CORREGINDUM No -1 dated 20.03.2008

- C) Clarification on vendor's queries received till date on Enquiry no. 4573285 dated 29.02.2008 for UPS Package are as under

Scale 1:75	C5	=20C00	+	/	A1
BALLIA-BHIWADI PROJECT 2500MW HVDC BIPOLE TERMINAL PACKAGE CONVERTER STATION (BHIWADI)				PTD H121/P-004364/EC5.842.CH	
				CONTRACT AGREEMENT No.C-46002-S656-1/CA-I	
			Date	01.08.07	CONTROL BLDG. (FIRST FLOOR)
			Drawn	JUGI	
			Appr.	RK/NK	
			Norm	RKOUL	(0)E50105 - A4017 - V003 - B
B	THIRD ISSUE	10.12.07	KV	Siemens AG	
A	SECOND ISSUE	20.10.07	KV		
0	FIRST ISSUE	01.08.07	RK		W.O. No. 86012/TB-2-291-316-212A
Rev.	Remarks	Date	Name

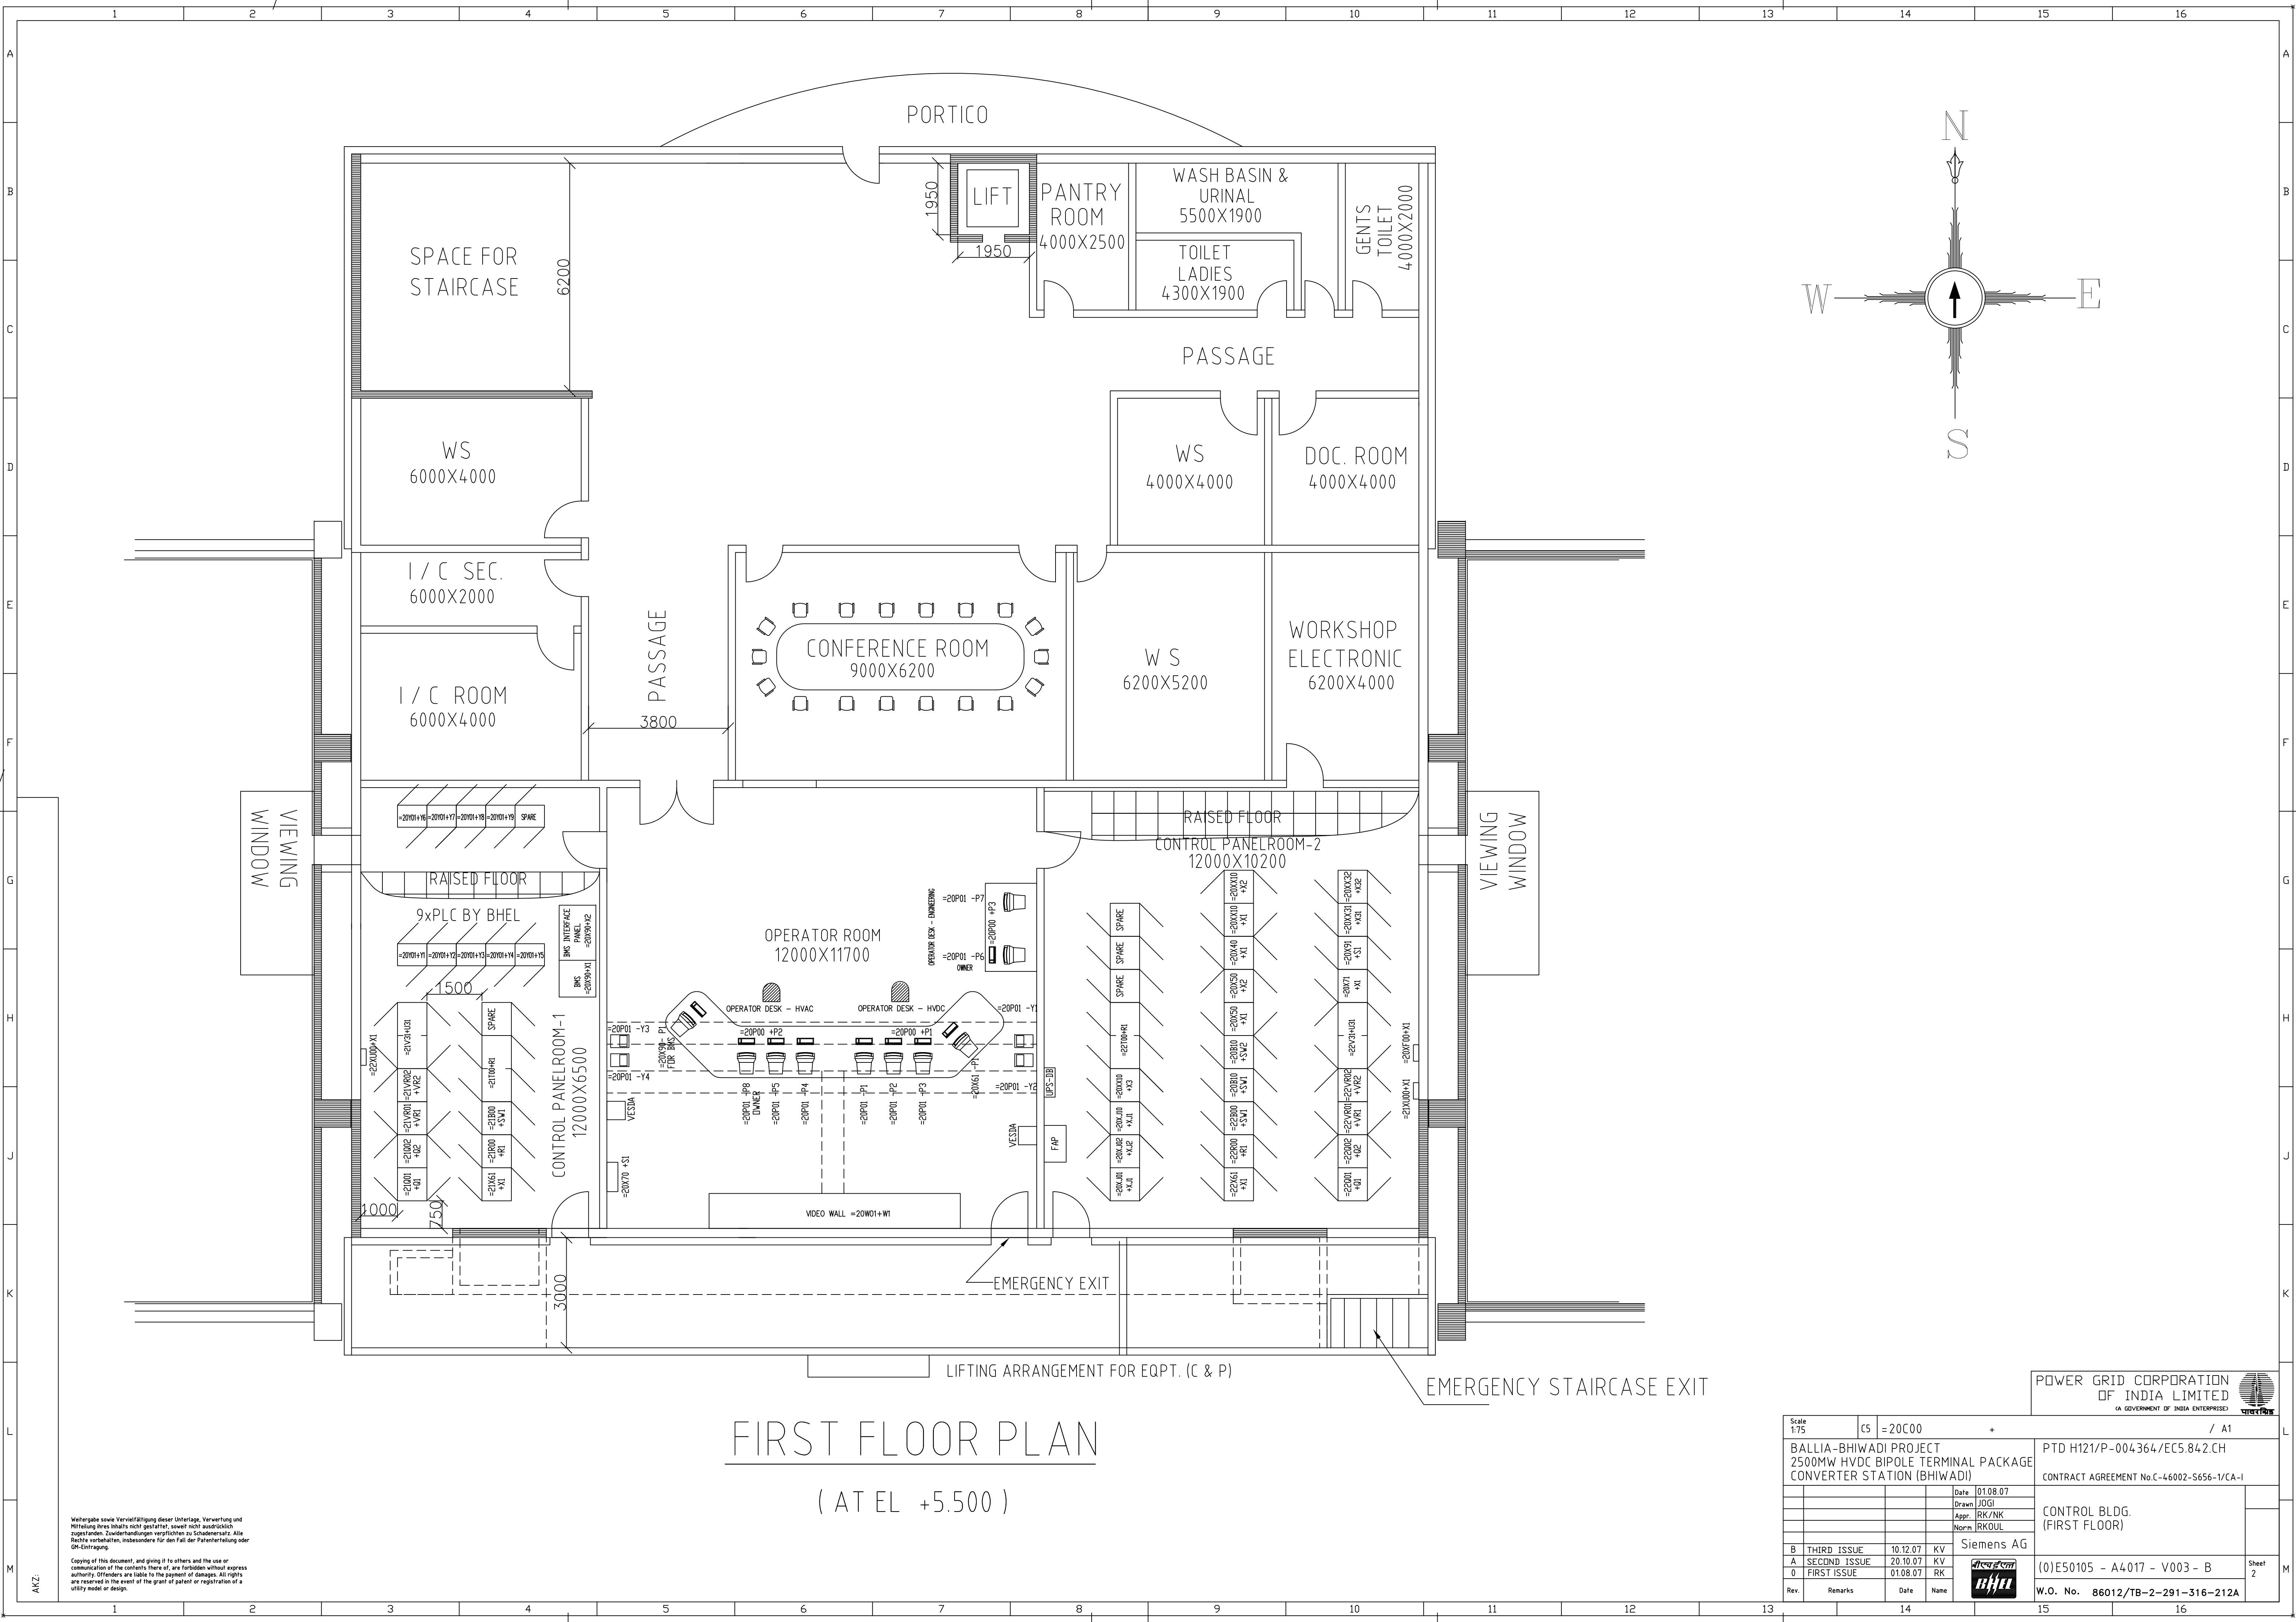
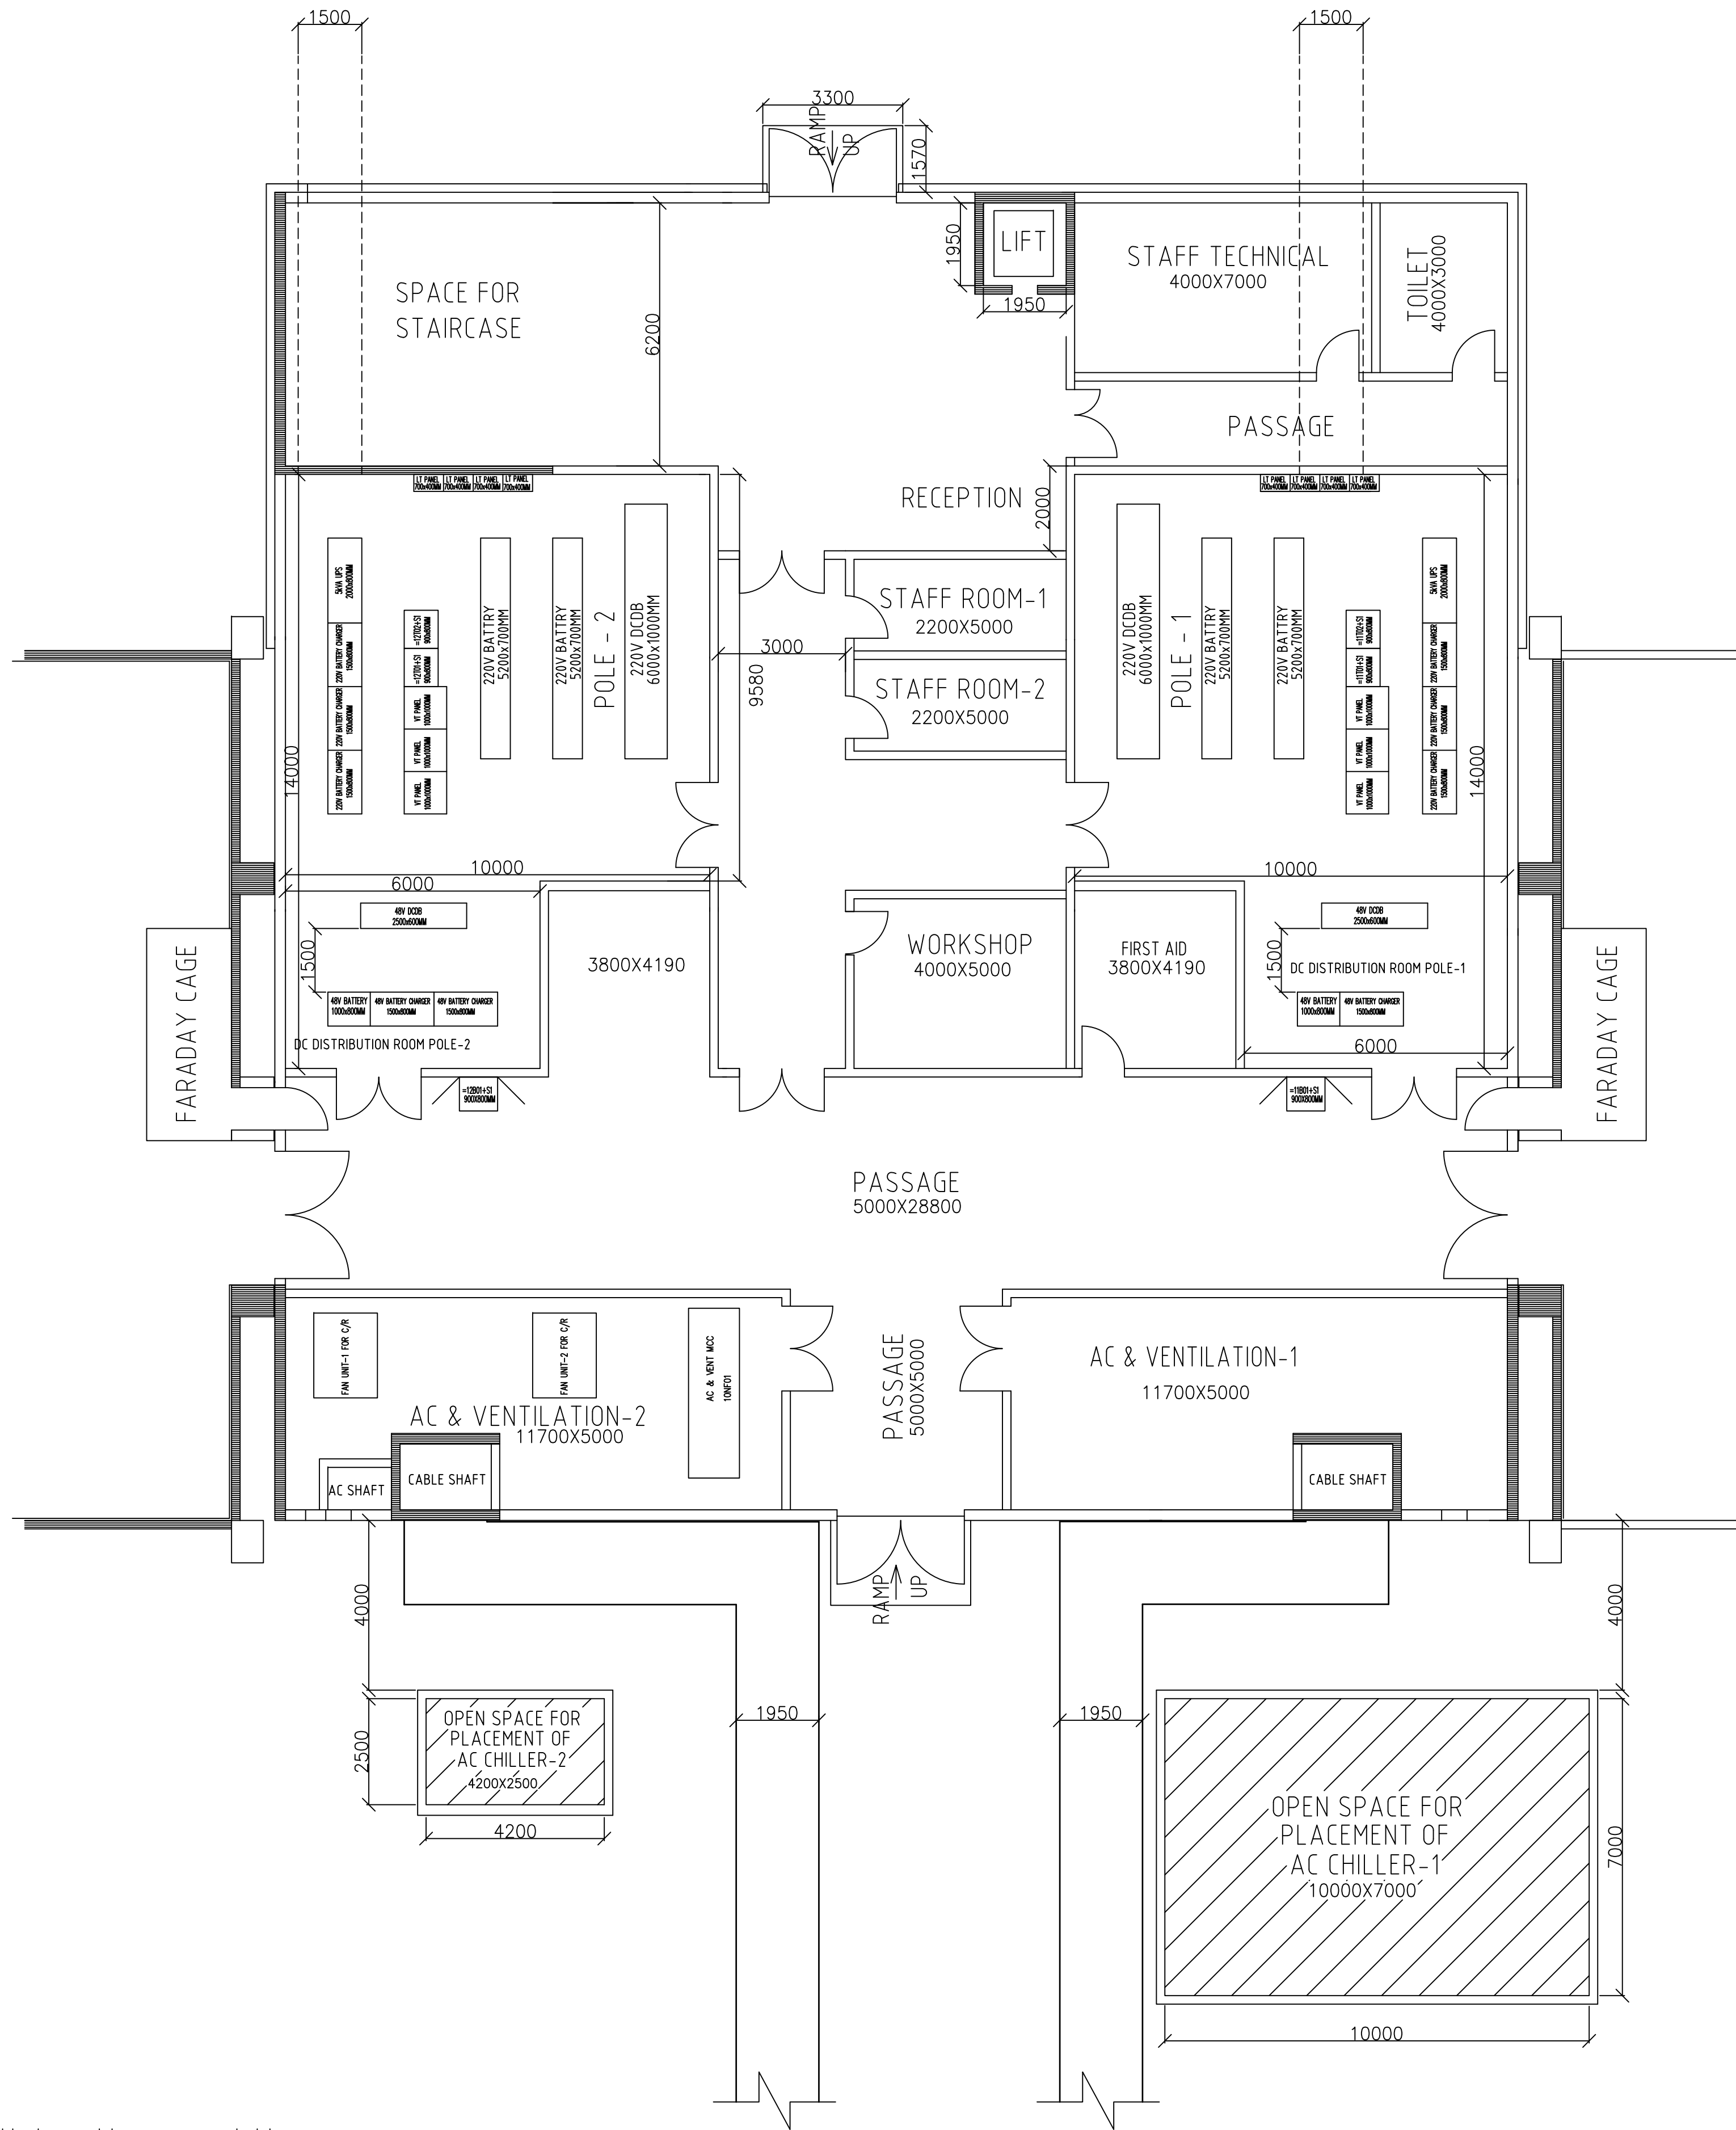
| Query 3) | Please provide us exact length and rating of Power, control and network cable. |

| Reply | Exact length to be calculated by the bidders at detailed engineering stage however the control room building Layout drawing is enclosed for your reference |
